STAFF REPORT AND RECOMMENDATION TO THE DESIGN COMMISSION - DENIAL

CASE FILE: LU 15-267105 DZM
PC # 15-243722
Hoyt 20 Apartments
REVIEW BY: Design Commission
WHEN: March 3, 2016, 1:30pm
WHERE: 1900 SW Fourth Ave., Room 2500A
Portland, OR 97201

PLAN - LEVEL 1
D18

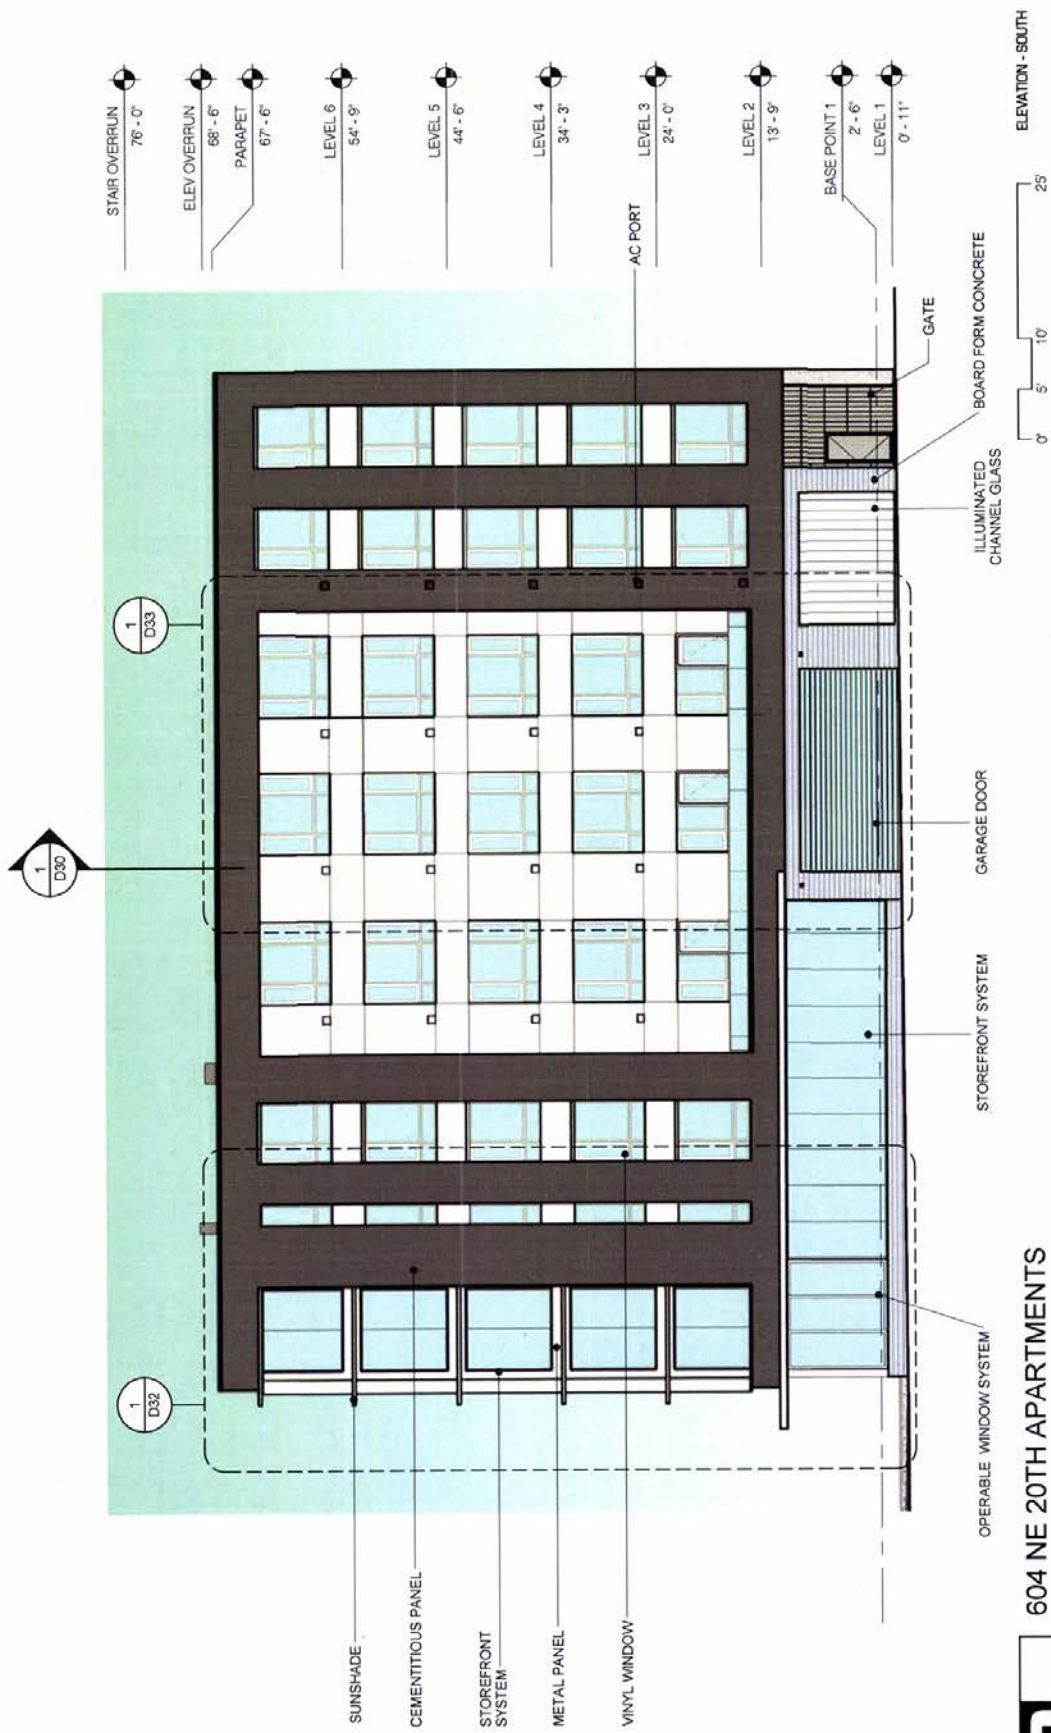
The at-grade parking is concealed within the building's interior and lined with active floor area fronting NE 20th Ave. On the NE Hoyt St elevation however, a significant amount of parking related floor abuts the sidewalk – garage door, loading stall and fenced egress stair. As such, this inactive floor area contributes to the need for a Modification to ground floor window standards. Drawings submitted by the Applicant indicate channel glass within the building wall as mitigation. However, the drawing set lacks details, specifications or illustrations in order to determine that such a treatment would sufficiently minimize negative impacts to the abutting public realm.

With additional measures – *reduced or eliminated parking frontage facing NE Hoyt St, deeper leasable retail space, more design detail related to channel glass treatment*

Findings: The modification to reduce the width of 6 of the 18 garage parking spaces from 8'-6" to 7'-9" due to required structural column layout is in keeping with other parking garages of this type. The remaining parking spaces will be a minimum of 8'-6" wide. The drive aisles and other maneuvering spaces as well as bike parking, stairways, ADA parking spaces, and pedestrian walkways will comply with code requirements so that vehicles can enter and exit as well as pass each other within the parking garage in a safe manner. The narrower spaces can accommodate regular sized cars while larger vehicles may have to drive a bit farther looking for a wider space. This selection of parking space sizes is a common feature of parking garages around the city and allows for more spaces to be provided within this development. This in turn relieves some of the parking burden that would have to be accommodated by on-street parking which can in-turn help satisfy the parking demand for area visitors and other short-term parkers. Therefore the at-grade garage and its parking space totals and layout help the project better meet guideline D4 Parking Areas and Garages. *Therefore, this modification merits approval.*

ELEVATION - WEST

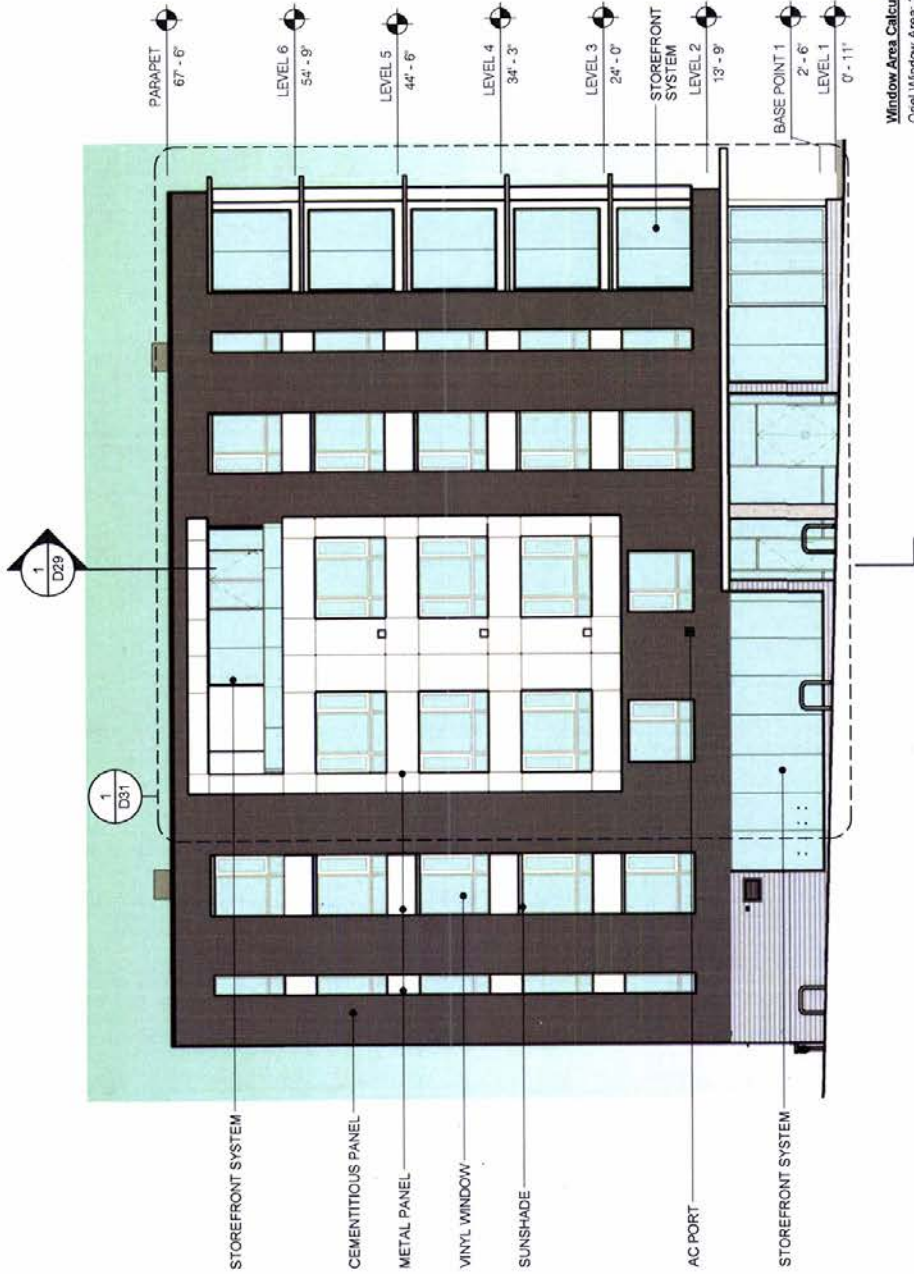
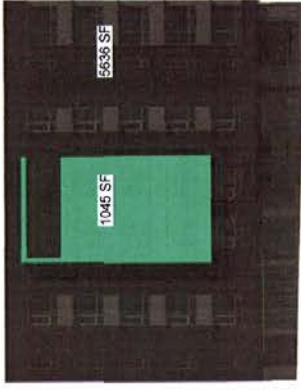
<p>Findings: The proposed projection is approximately 27' wide. This Criterion is not met but is approvable with (1) compliance with standards C and D, and (2) a</p>

favorable recommendation through Design Review. Standards C and D are met. With regard to Design Review consideration as described above, the Oriel expression lacks contextual relevance and contributes to the design's non-compliance with approval criteria – P1 Plan Area Character, D7 Blending into the Neighborhood, D8 Interest, Quality and Composition. ***This Criterion is not met.***

Therefore, Staff does not recommend approval of this requested exception.
